**Before the Independent Hearing Panel appointed by
the Canterbury Regional Council**

IN THE MATTER OF Application CRC190445 to
discharge stormwater to land and water

Section 42A Officer's Report

Report of Michael Law

Figure 2 – Avon surface water network

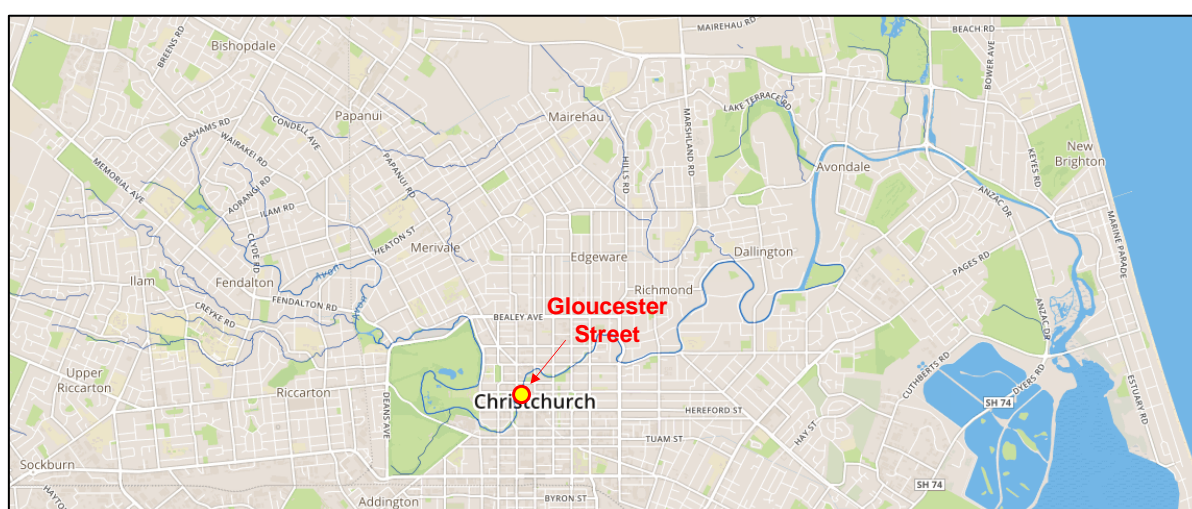
25. With performance only being measured at one location in each of the four modelled catchments, this will not reflect variations in effect across the catchment. Indeed, where the proposed target location is not at the outfall of the catchment, there is no mechanism by which CRC can control increases in downstream flood level, which could occur with unmitigated development downstream of the target location.

26. For example, the control location for the Avon catchment is Gloucester Street Bridge in the city centre. Approximately 75% of the Avon's stream network is downstream of this location (Figure 2) which means that the CSNDC will not control stormwater in the Avon catchment downstream of this point.

27. To resolve this issue, I recommend that multiple performance monitoring locations are identified in each modelled catchment.

Figure 2. Pūharakekenui/ Styx - Suggested monitoring locations

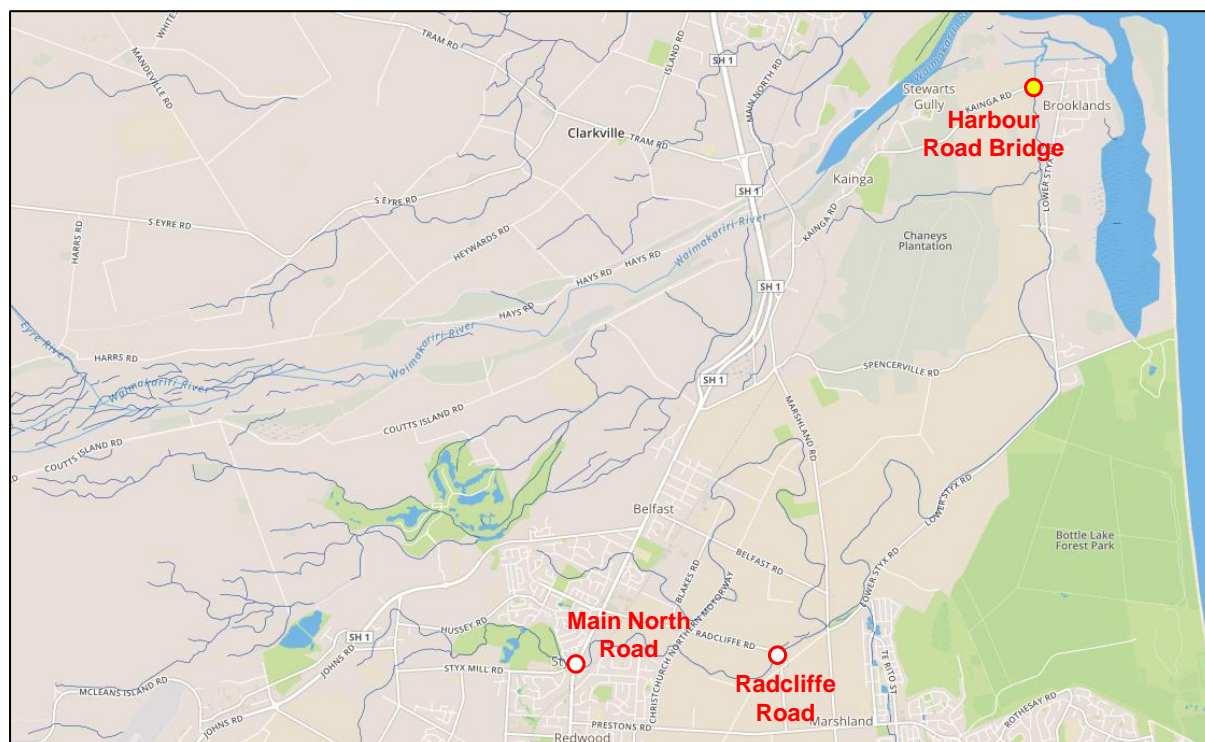
31. CCC's proposed monitoring location for the Styx catchment is at Harbour Road Bridge, close to the downstream limit of the catchment. As such it would meet the requirement of being far enough downstream as to ensure that any potential development within the catchment is upstream of the performance monitoring location. However, being so close to the downstream limit means that water levels are affected by the operation of the tide gates and the ability to discharge water to the tideway. As such, peak water levels may be affected by changes in downstream boundary conditions.

32. I suggest that Harbour Road Bridge is retained as a performance monitoring location due to its downstream location and the sensitivity of the area to flooding, as evidenced by the comments of submitters.
33. However, I also propose additional locations further upstream in the catchment; at Radcliffe Road and Main North Road, as shown on Figure 3. These additional sites will allow the contributions from the upper catchment to be assessed, with a focus on peak flows that is not possible in the tide-locked or ponded lower part of the catchment.

Figure 3. Otākaro/ Avon - Suggested monitoring locations

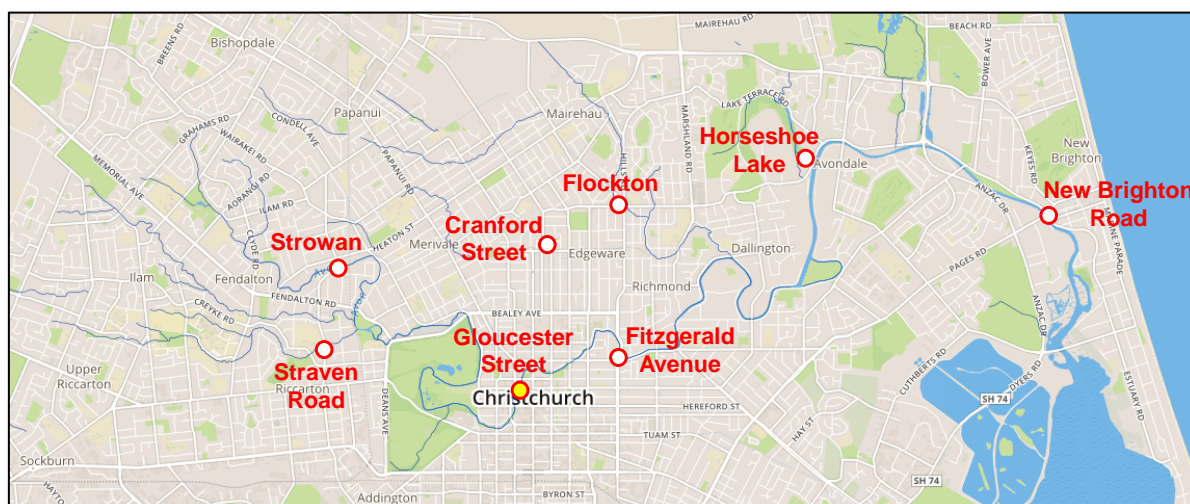
34. The additional performance monitoring locations that I suggest for the Avon catchment are based on the locations listed in Table 6-1 of the Avon SMP Blueprint for which peak flood levels are reported. The Avon SMP Blueprint only names the sites, and does not provide a locations map. Therefore, the locations that I have marked on Figure 1 may not be in exactly the correct place. However, the selected locations provide good coverage of the catchment and allow mitigation measures to be targeted to sub-catchments where development pressures are having a more pronounced effect.

Figure 4. 3.1.3 Ōpāwaho/ Heathcote- Suggested monitoring locations

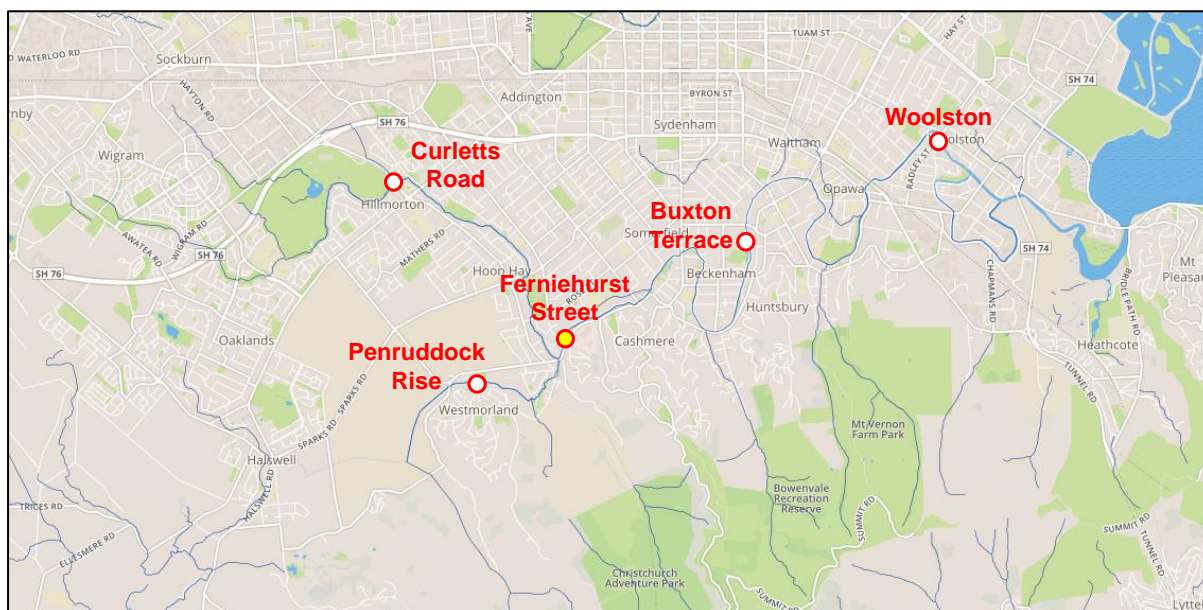
35. Only monitoring the Heathcote at Ferniehurst Street presents the same issues as with only monitoring the Avon at Gloucester Street, namely that a large part of the catchment is downstream of the monitoring location. Therefore, I suggest two additional monitoring locations downstream of Ferniehurst Street. While the location at Woolston may be tidally affected, the effects of tide and sea level rise can be neutralised in the models, such that differences in modelled water levels will only reflect changes in the catchment.
36. The majority of development pressures in the Heathcote catchment are upstream of Ferniehurst Street; with particular note being made of:

- a. Sub-divisions along the Port Hills at Worsley and Westmoreland;
- b. Ongoing development at Wigram;

- c. Development and stormwater management at Spreydon Lodge; and
- d. Cross-catchment flows between the upper Halswell and Heathcote catchments.

- 37. Therefore two monitoring locations are proposed upstream of Ferniehurst Street; Penruddock Rise on the Cashmere Stream and the Heathcote River at Curletts Road.

Figure 4. 3.1.4 Huritini/ Halswell - Suggested monitoring locations

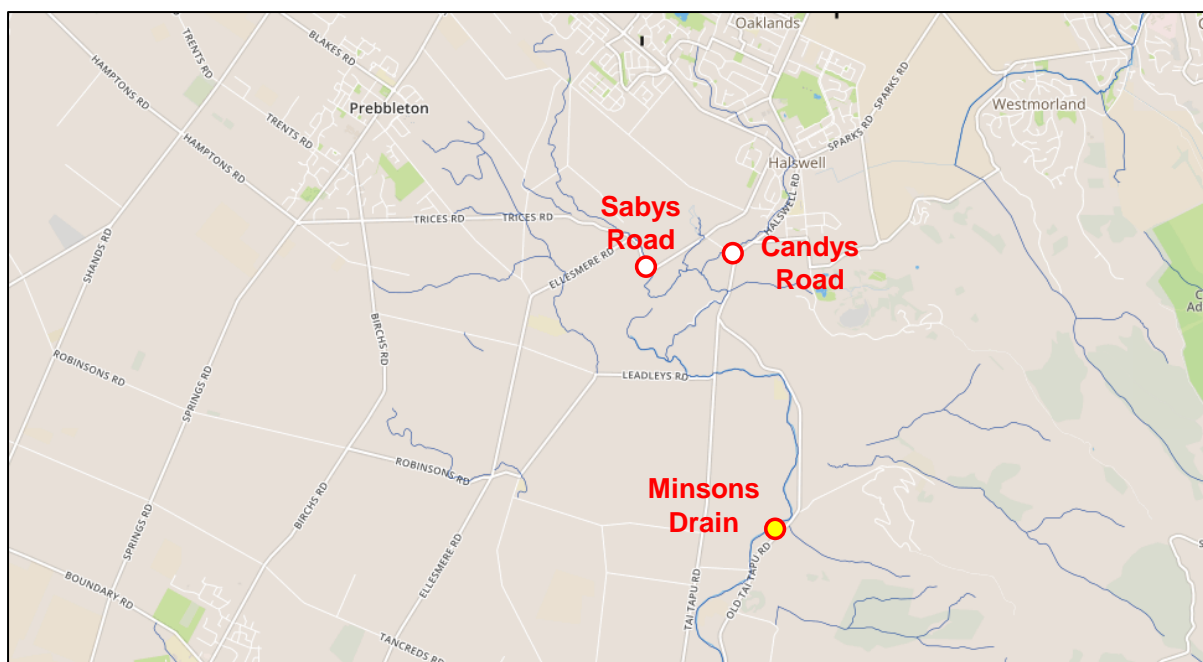
- 38. CCC's proposed monitoring location on the Halswell River at the Minsons Drain confluence is appropriate, as it is City boundary. Downstream, the river flows through Selwyn district to Lake Ellesmere / Te Waihora. However, I recommend that additional locations are added on Nottingham Stream and Knights Stream to provide better protection to individual sub-catchments.

- 39. The Halswell River is sensitive to flood volume, as well as peak water level or flow. This is not addressed by CCC's proposed performance monitoring at the Minsons Drain confluence. An additional approach would be to set a performance target based on the amount of time that water levels remain above a threshold that is based on the level at which the river spills further downstream.

- 40. CCC's proposed condition refers to the "critical duration event", but does not indicate whether this is the critical duration for the upper part of the catchment within CCC's boundary, or the whole of the Halswell River catchment. The critical duration event for the whole catchment is estimated to be 60 hours, far longer than the critical duration for the other Christchurch catchments.

Figure 6. Otukaikino Catchment map

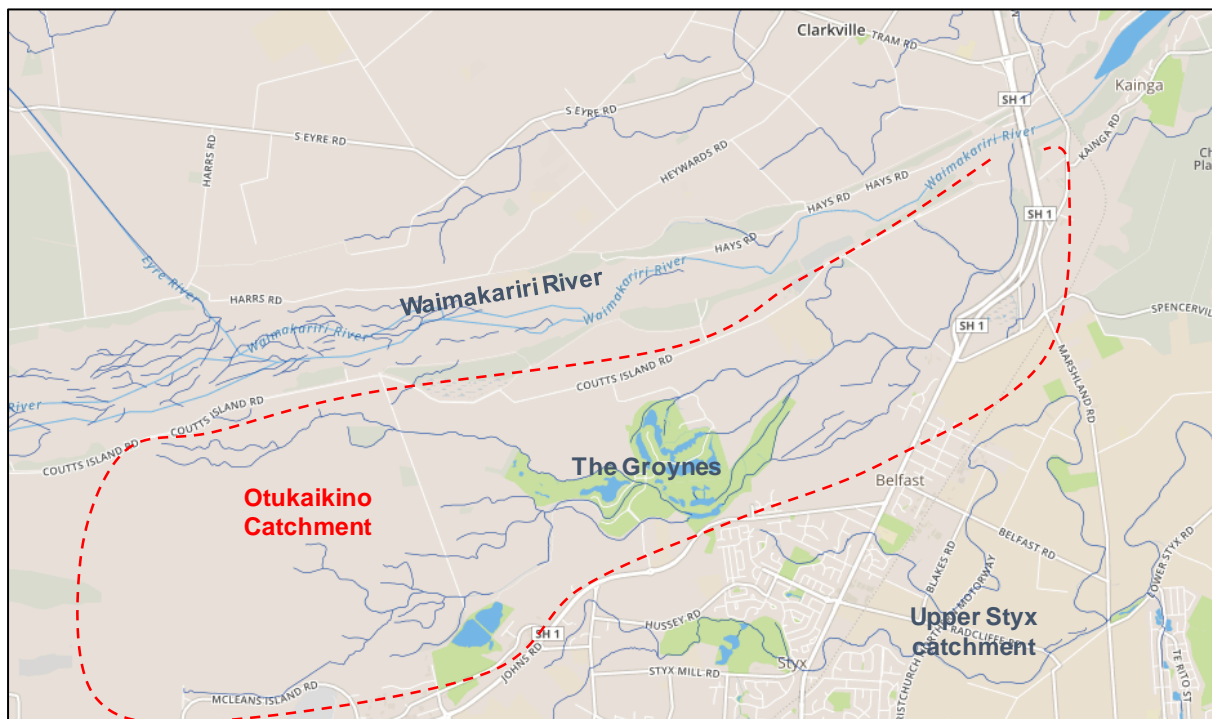
69. The Otukaikino catchment lies to the northwest of the city, between Belfast and the Waimakariri River (Figure 6). Flooding occurs due to backwater effects in the Waimakariri River. CCC doesn't record water level in the Otukaikino River, and the catchment is not modelled.

72. Whereas it is possible to take a catchment-wide approach to measuring stormwater performance in the modelled catchments, the approach proposed in the Otukaikino catchment relies on managing flood risk at the development scale, with the expectation that this will provide the required performance at the catchment scale.

73. I have not reviewed any evidence of whether the partial detention approach delivers the desired catchment-wide performance with regard to managing flood risk within acceptable limits. In the absence of catchment-wide modelling, managing runoff peaks and volume at the development scale is a pragmatic approach in the current situation.

74. The proposed lifespan of the CSNDC consent is 25 years. Is it anticipated that a stormwater model of the Otukaikino catchment will not be developed over that time, or that the catchment will not be incorporated within the city-wide stormwater model? Given advances in modelling capability and efficiency, I would expect that the catchment could be modelled effectively within that time period. In which case, should the proposed conditions reflect future opportunity to measure stormwater performance in a comparable manner to that proposed for the four modelled catchments?
